Work Order ID 98184

Item Name: Crosstube Mid Fwd, Blue

DART AEROSPACE LTD HAWKESBURY, ONTARIO, CANADA	
DRAWING NO. D206-667-147	REV. A SHEET 1 OF 4
TITLE CROSSTUBE ASSY (206L MID FWD)	SCALE NTS
COPYRIGHT © 2010 BY DART AEROSPACE LTD THIS DOCUMENT IS PRIVATE AND CONFIDENTIAL AND IS SUPPLIED ON THE EXPRESS CONDITION THAT IT IS NOT TO BE USED FOR ANY PURPOSE OR COMMUNICATED TO ANY OTHER PERSON WITHOUT WRITTEN PERMISSION FROM DART AEROSPACE LTD.

DRAWING NO. D206-667-147	TITLE CROSSTUBE ASS'Y (206L MID FWD)	REV. A	DART AEROSPACE LTD ENGINEERING ORDER		D.E.O. NO. D206-667-147-A-1	SHEET NO. SHEET 1 OF 1	SCALE NTS
DRAWN <i>q</i>	CHECKED <i>ASS</i>	MFG. APPR. <i>JB</i>	APPROVED <i>MD</i>		DE APPR. <i>MD</i>		
DATE 11.07.15	DATE 11.07.20	DATE 11.07.21	DATE 11/07/21		DATE 11.07.21

DRAWING NO. D206-667-147	TITLE CROSSTUBE ASS'Y (206L MID FWD)	REV. A	DART AEROSPACE LTD ENGINEERING ORDER		D.E.O. NO. D206-667-147-A-2	SHEET NO. SHEET 1 OF 1	SCALE NTS
DRAWN AJS	CHECKED	MFG. APPR.	APPROVED		DE APPR.		
DATE 12.08.02	DATE 12.08.02	DATE 12.08.02	DATE 12.08.02		DATE 12.08.02

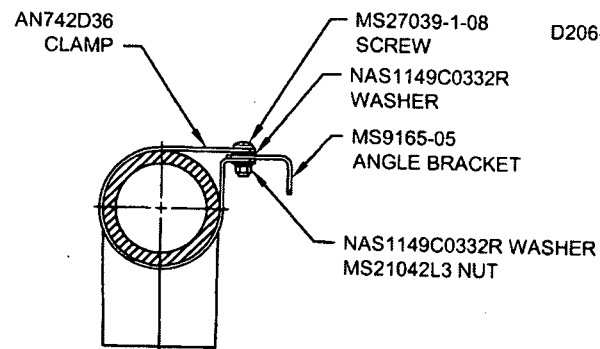
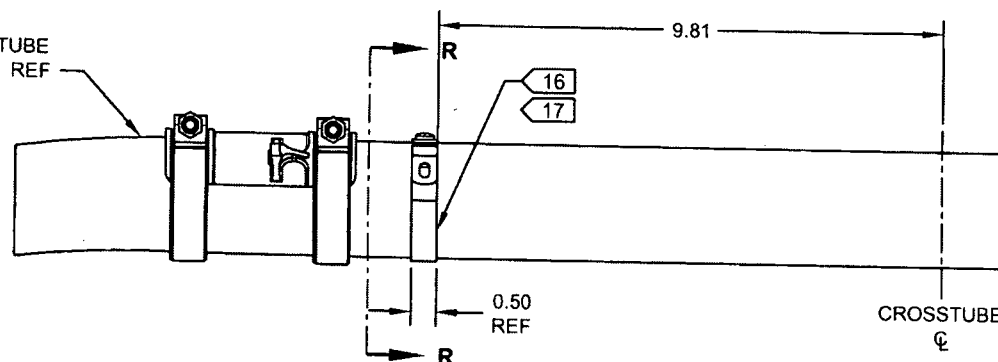
ADD ELECTRICAL GROUNDING STRAP

- 16) MASK AREA UNDER CLAMP PRIOR TO PAINTING
- 17) SEAL EDGES WHERE AN742D36 CLAMP MEETS WITH THE CROSSTUBE USING SIKAFLEX-241/-291 OR MIL-S-8802 CLASS B2 OR PROSEAL 890 SEALANT
- 18) PERFORM RESISTANCE CHECK TO ENSURE MAX RESISTANCE IS 10 MILLIOHMS
